SUBJECT: Forwards marked-up responses to NRC 801230 questions re instrumentation & controls sys. Responses will be incorporated into FSAR amend within 4 months.

Subject: SUPPLY SYSTEM NUCLEAR PROJECT NO. 2
RESPONSES TO INSTRUMENTATION AND
CONTROLS SYSTEMS BRANCH QUESTIONS

Reference: Letter, RL Tedesco to RL Ferguson, "Additional WNP-2 Questions (ICSB)", dated December 30, 1980.

Q. 031.127
(F7.7-3c)

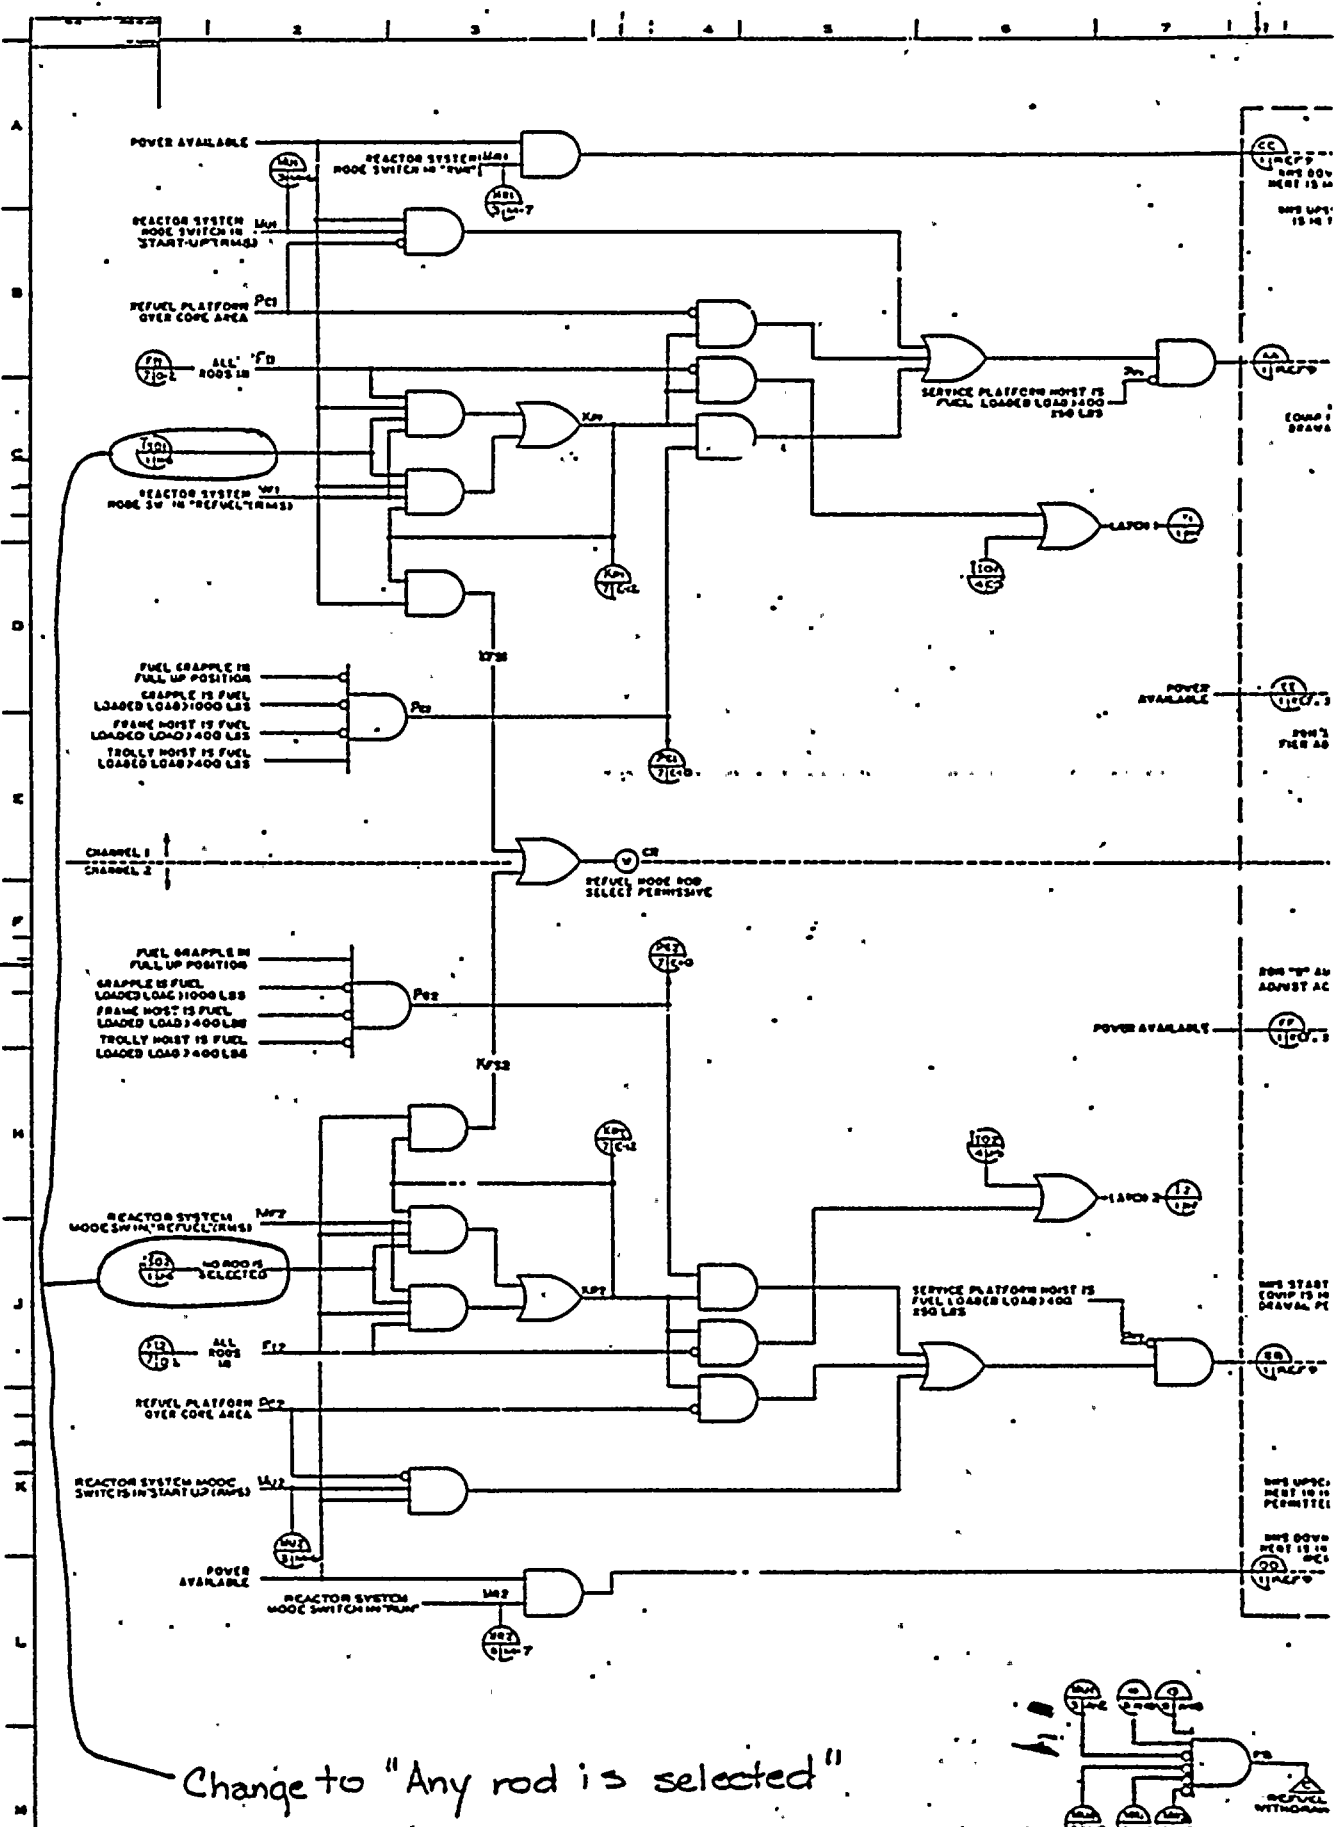
The title for signal Iso₂ at location J1 and for signal Iso₁ at location C1 (shown in Figure 7.7-3c) should be "any rod selected," rather than "no rod selected." Correct this discrepancy.

The WNP-2 FSAR Figure 7.7-3c has been changed.*

Change to "Any rod is selected"
